A303 Amesbury to Berwick Down

TR010025

**8.30.5 - Written summaries of oral submissions put at
Noise, Vibration, Health and Wellbeing
hearing on 12th June 2019**

June 2019

Drawing Title
**FIGURE 9.4
SHORT TERM CHANGE IN TRAFFIC NOISE LEVELS – 2026 DO-SOMETHING MINUS 2026 DO-MINIMUM INSETS ADDED AT PORTALS**

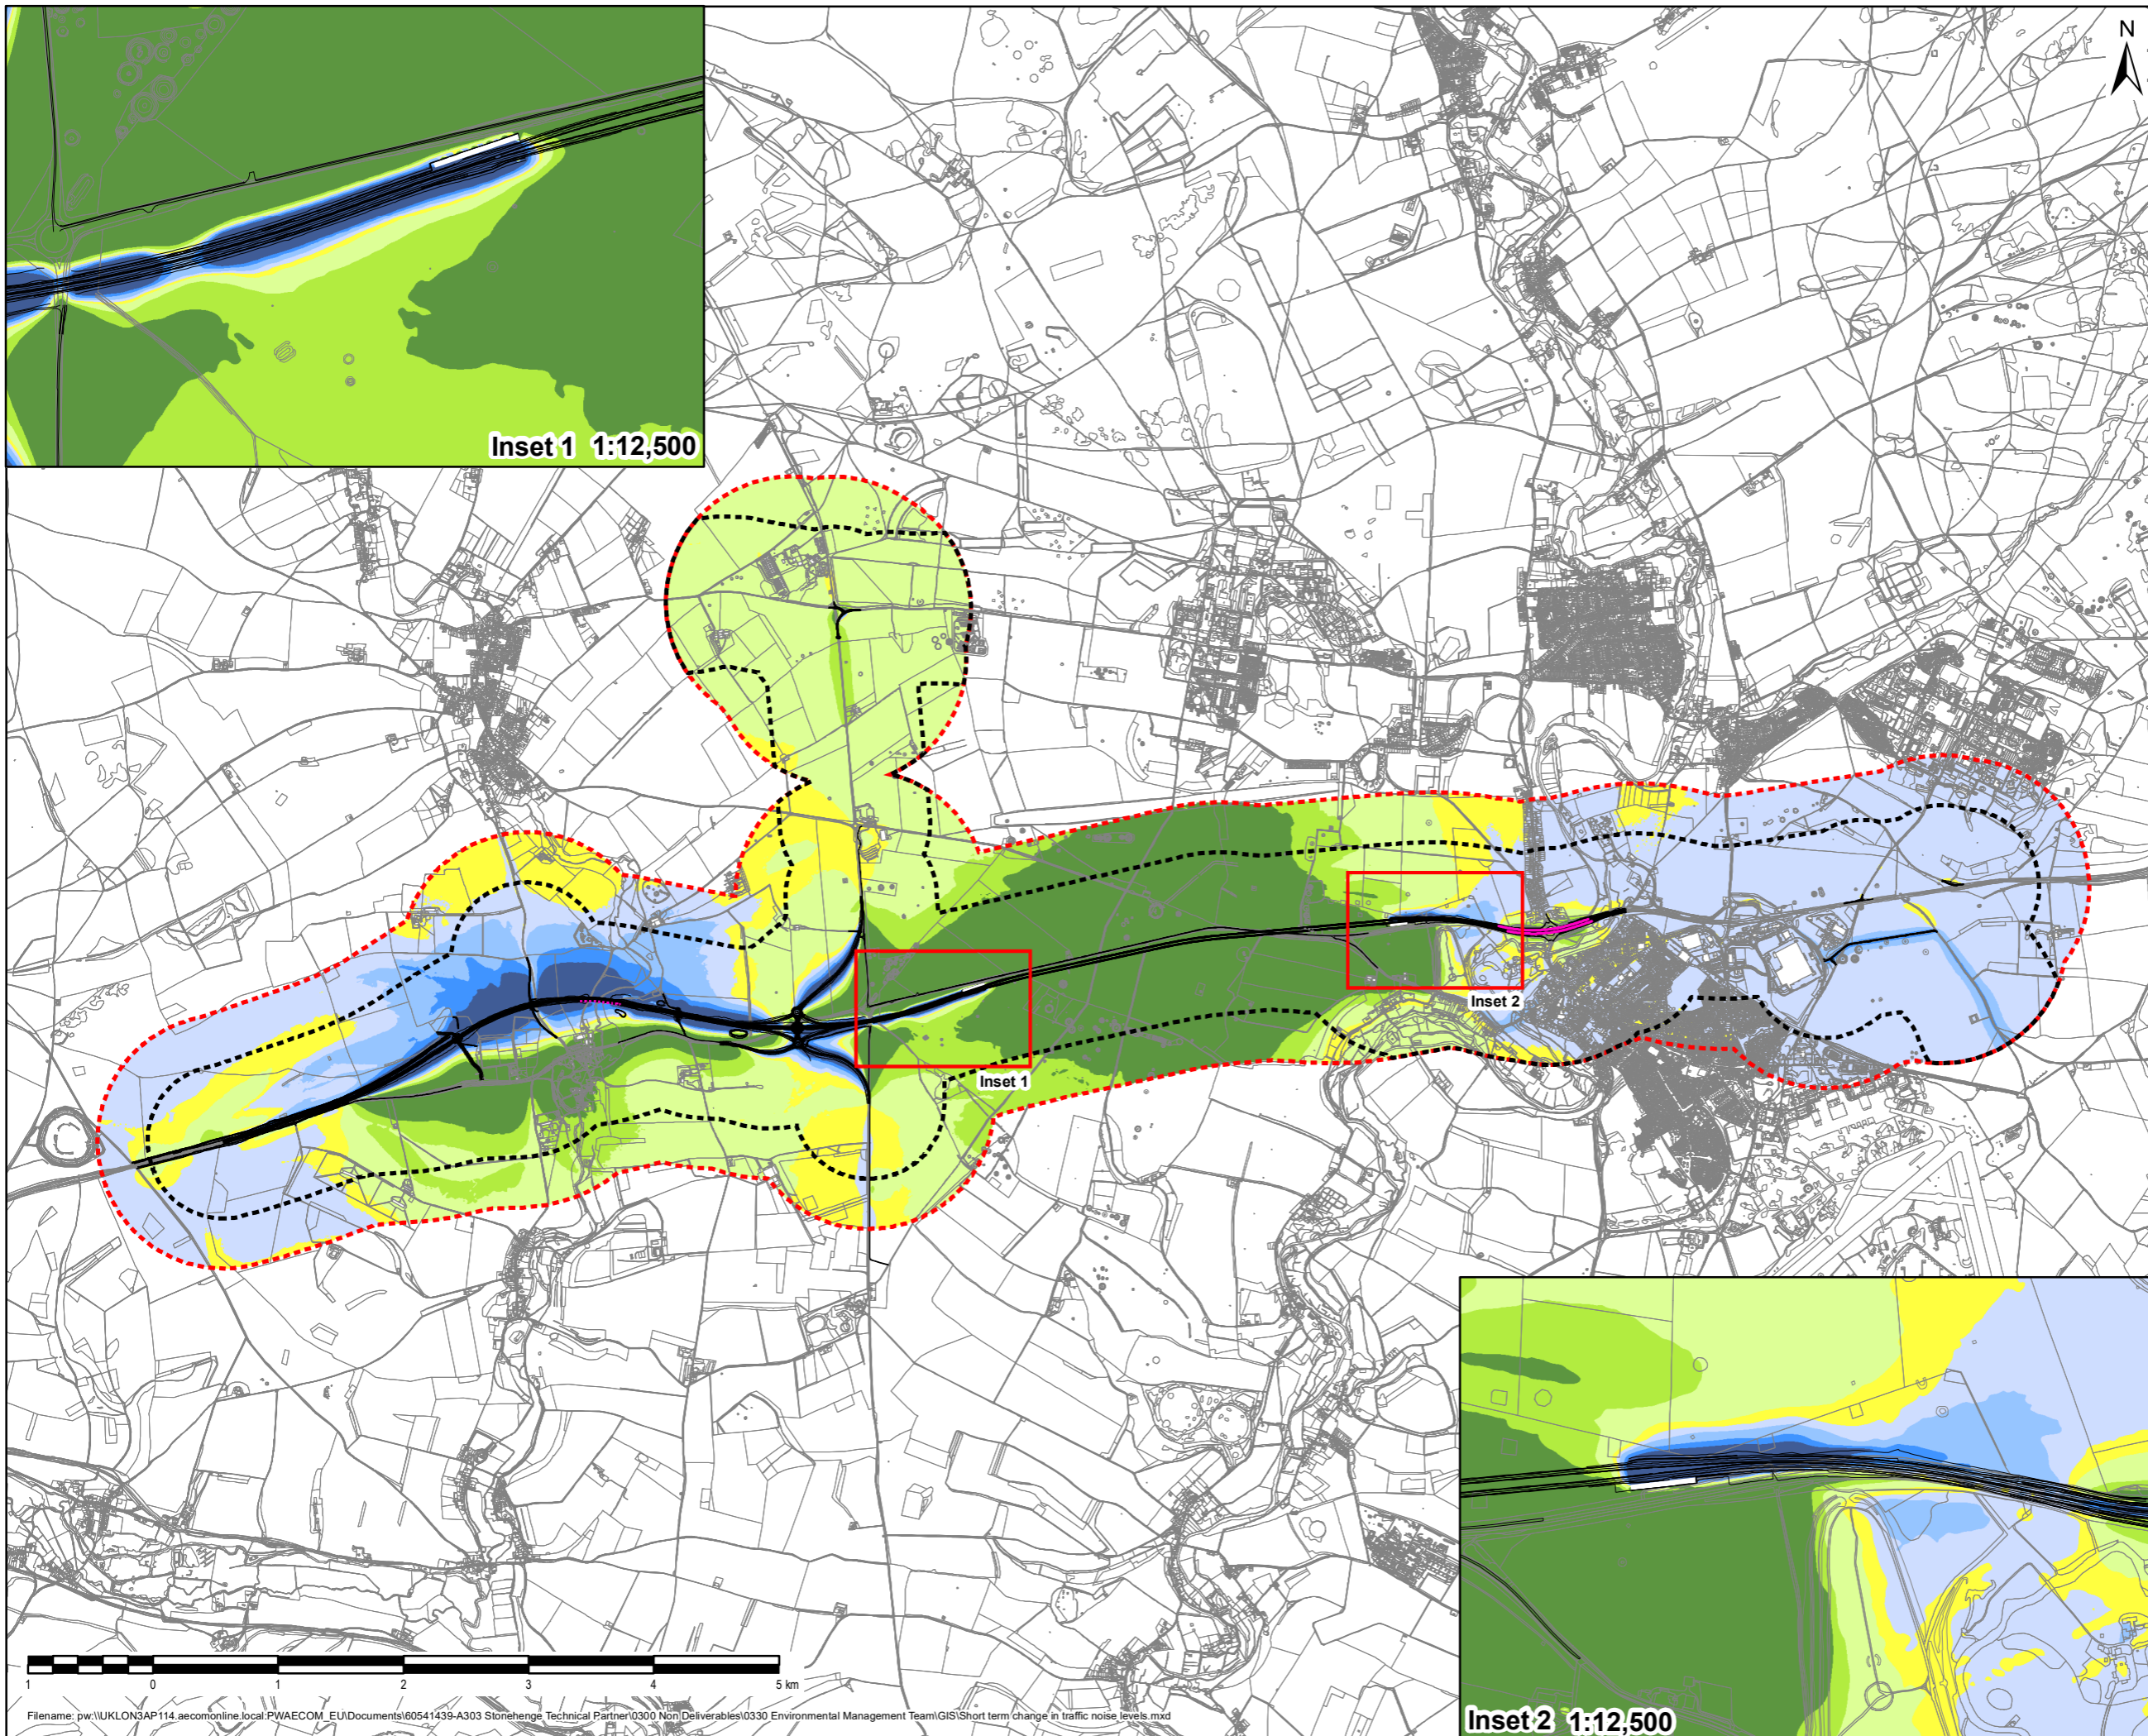
<p>Ms Scott explained that Chapter 7 (Landscape and Visual) of the ES [APP-045] contained an assessment of tranquillity in accordance with the Design Manual for Roads and Bridges ("DMRB").</p> <p>Richard Hammond, on behalf of the Applicant, confirmed that noise was considered as part of the assessment of impacts on tranquillity contained in the ES – this included considering the impacts on Landscape Character Areas, amongst other things.</p> <p>Paul Brown QC confirmed that Wiltshire Council was content with the policy and approach to assessment of tranquillity.</p>
4 <u>ENVIRONMENTAL STATEMENT CHAPTER 9 [APP-047]</u>	
<u>Agenda Item</u>	<u>Highways England response</u>
<p><i>i. Noise assessment in respect of tunnel portals and cuttings</i></p>	<p>The Examining Authority asked how the ES has considered whether an increase in traffic speed and flow can result in higher noise levels.</p> <p>Suzanne Scott explained that the DMRB acknowledges that although putting a road into a tunnel will eliminate the noise from the enclosed section, there is potential for additional noise to be emitted at either end of the tunnel, and that a noise absorptive surface within the entrance of the tunnel will reduce this. Therefore, this approach has been adopted in the scheme design and is secured in the revised OEMP [REP3-006] submitted at deadline 3 (D-NOI6). Cuttings (and false cuttings) mitigate traffic noise levels in the same way as a noise barrier by blocking line of sight from the road to a receptor. Overall, noise levels would reduce along the current alignment of the A303 but increase along the new alignment outside of the tunnel portals.</p> <p>The Examining Authority asked for a specific reference to a noise profile to show effects at the tunnel portals.</p> <p>Ms Scott explained that the noise models used for the assessment were based on a 3D model which takes into account topography. The 2D traffic noise change contour plans as submitted with the Environmental Statement illustrate this for the short term change in the opening year in Figure 9.4 [APP-167] and the long term change from the opening year to 15 years after opening Figure 9.5 [APP-168].</p> <p>Reuben Taylor QC suggested the issue might be a presentational one in terms of the scale of the plans. He confirmed the Applicant would produce a further drawing at a different scale to enable interested parties to better establish the predicted change in traffic noise levels at the tunnel portals. This drawing with reference HE551506-AMW-DR-GI-00607 is appended to this note at Appendix 1.</p> <p>Howard Smith on behalf of Mrs P Sandell, asked whether the cottages situated at Park Farm will experience more or less noise as a result of the Scheme.</p> <p>Ms Scott noted that the closure of Stonehenge Road at that location as a result of the Scheme, together with the new road being in a deep cutting at the nearest location to the cottages, will mean there should be a beneficial impact at this location. This is illustrated in Figure 9.4 [APP-167].</p>

Post Hearing Note: *The Applicant notes that a 3 dB reduction in traffic noise is the onset of a potentially significant beneficial effect in the short term, the actual anticipated reduction in traffic noise at the Stonehenge Monument is rather greater, as illustrated on Figure 9.4 of the ES [APP-167].*

Drawing Title
2026 DO-SOMETHING TRAFFIC NOISE LEVELS

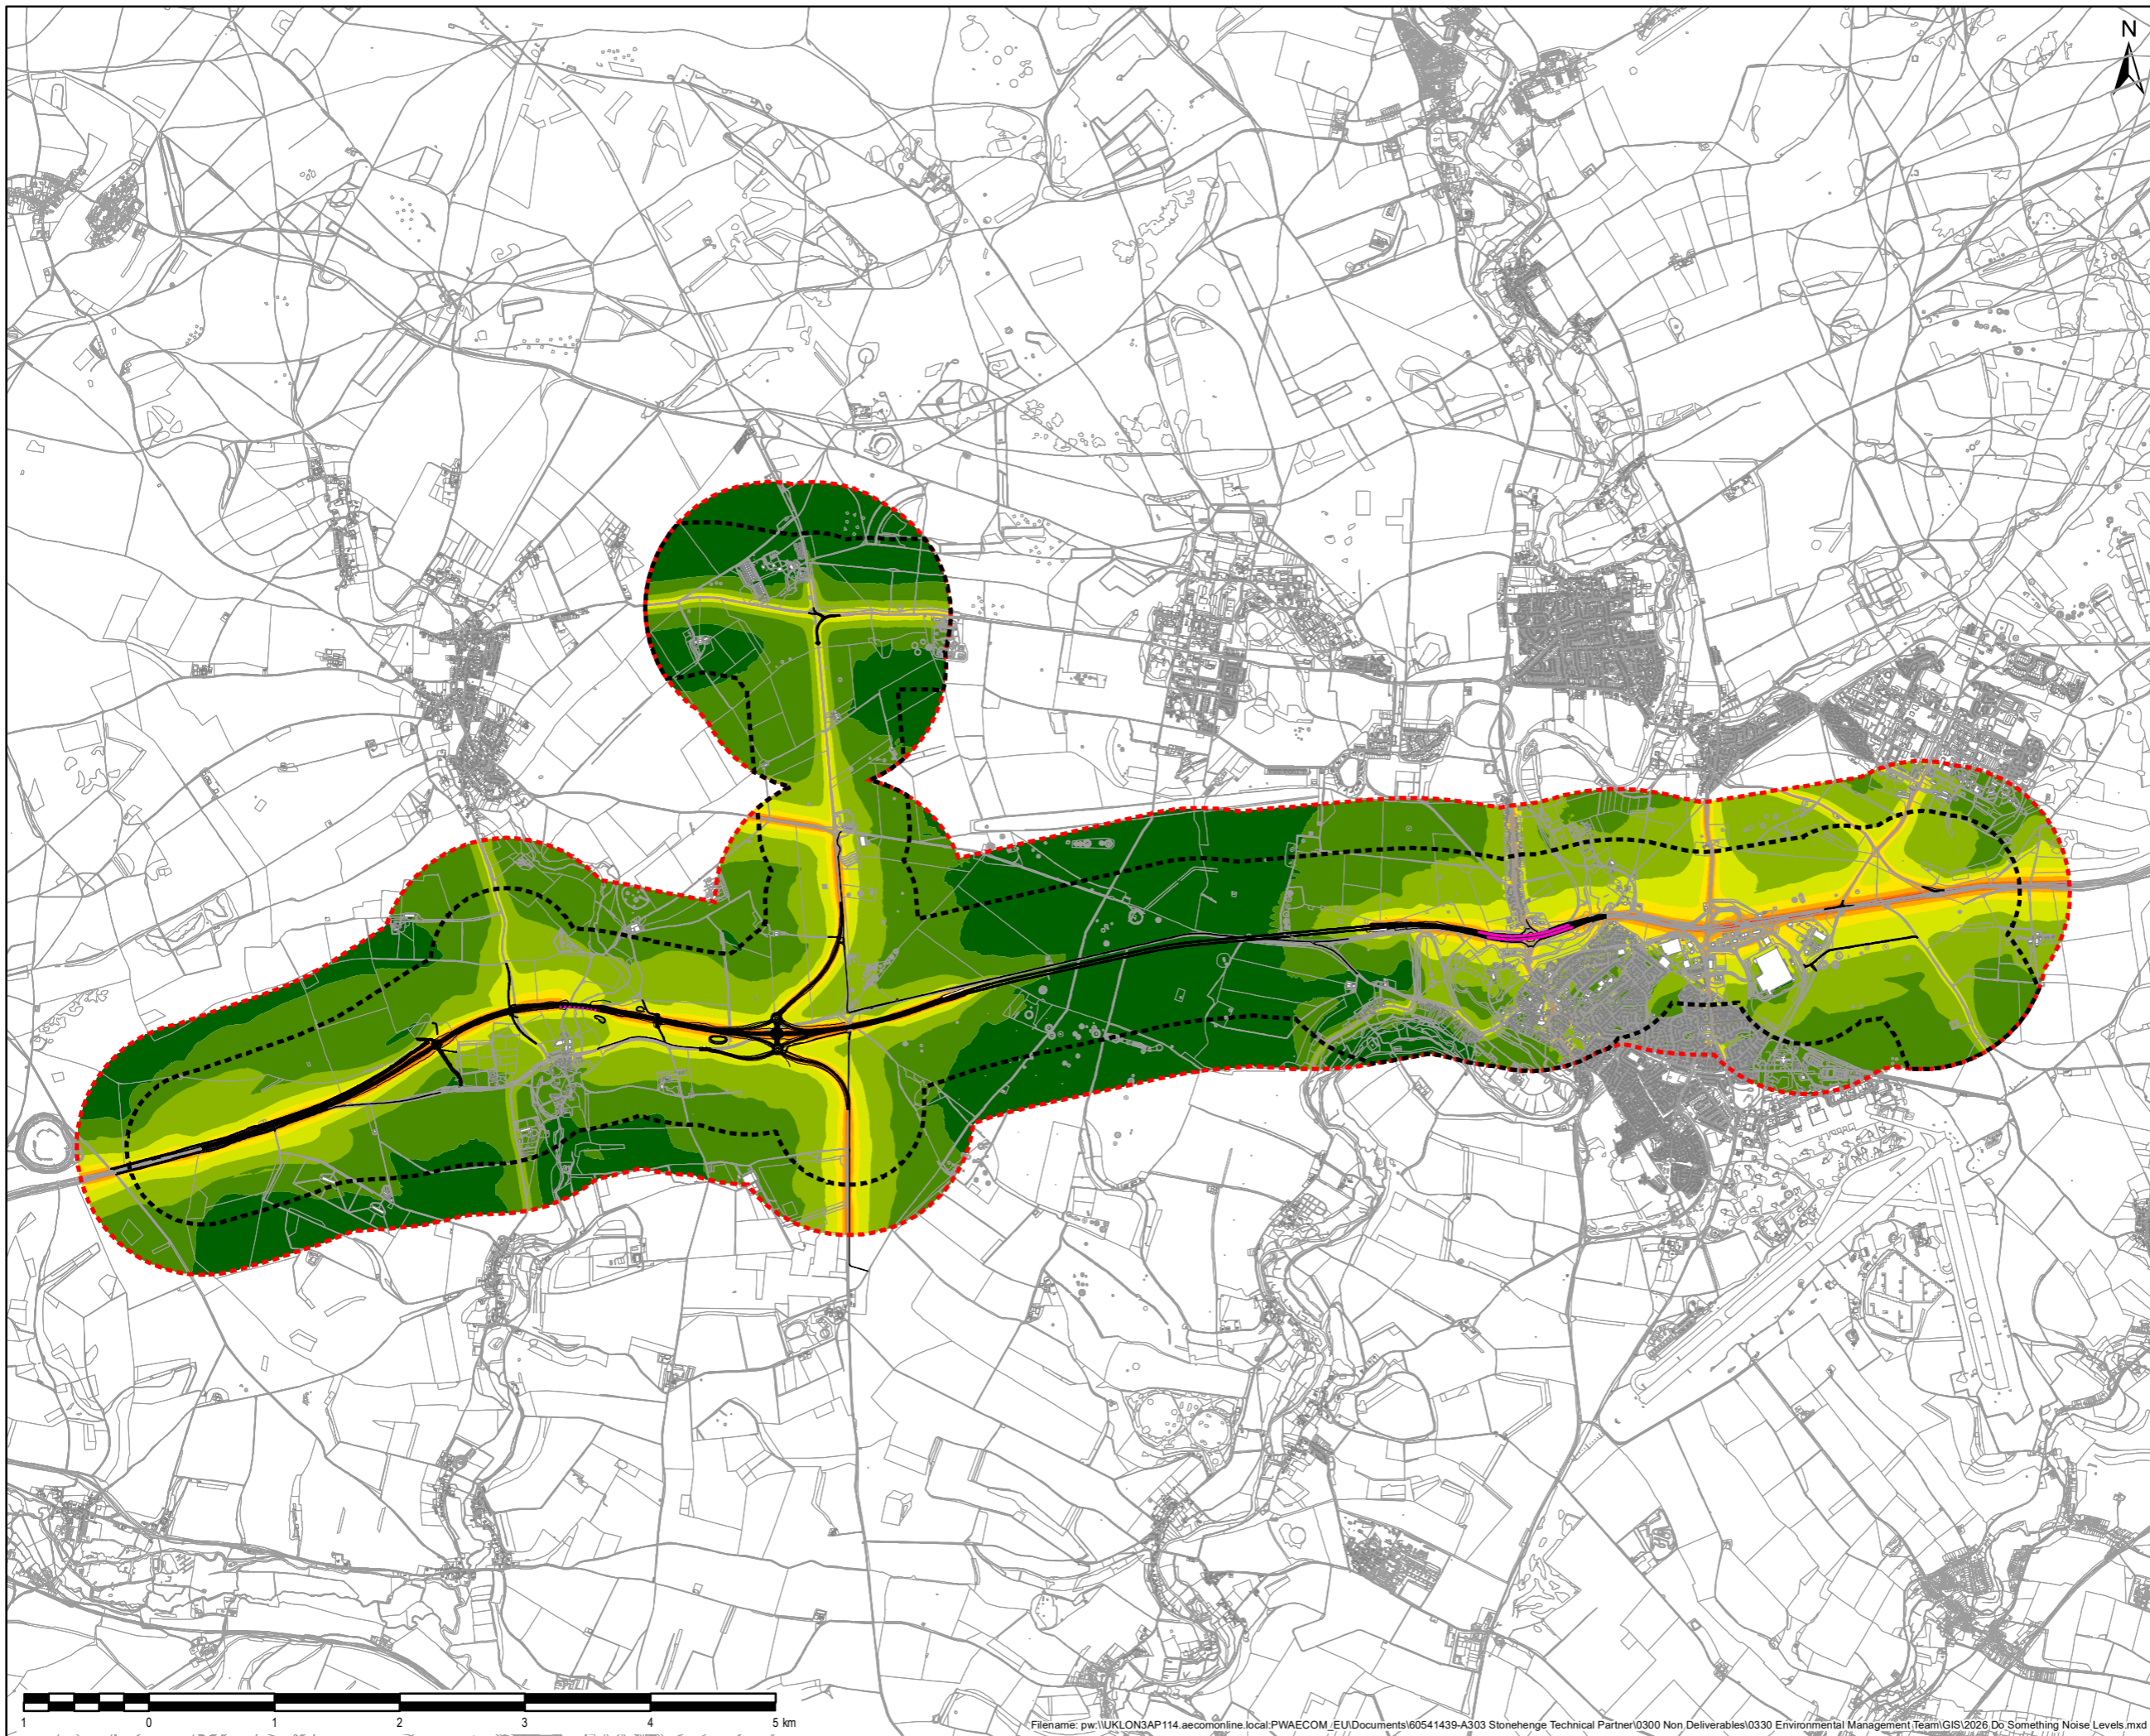
<p>iii. Background noise levels 'do minimum' and 'do something' alternatives</p>	<p>The Examining Authority queried whether any figures showing absolute noise levels in both the 'do minimum' and 'do something' scenarios had been submitted.</p> <p>Suzanne Scott explained that such figures were not required by the DMRB, so did not form part of the ES, but stated that they could be produced. As a result, it was agreed that the Applicant would submit these at Deadline 4. The figures are appended to this note at Appendix 2, with drawing numbers HE551506-AMW-DR-GI-00608 and HE551506-AMW-DR-GI-00609, for the Do-Minimum and Do-Something absolute traffic noise levels in the opening year respectively.</p> <p>Rollo Maughfling queried that if the western portal of the Scheme is not yet constructed, how can noise levels be assessed. Wind direction is an important factor and it was asserted that no evidence had been produced in respect of peace and tranquillity.</p> <p>Ms Scott explained that the assessment in the ES takes account of wind direction by assuming moderate adverse wind conditions at every receptor. Mitigation measures set out in the OEMP [REP3-006] at the portals would minimise noise impacts from the portals, including thin road surfacing and absorptive materials on the roof and walls of the tunnel entrance/exit.</p> <p>In response to a query from Mr Garwood, Mr Taylor QC confirmed that no assessment of the noise impacts on drivers within the tunnel had been undertaken.</p>
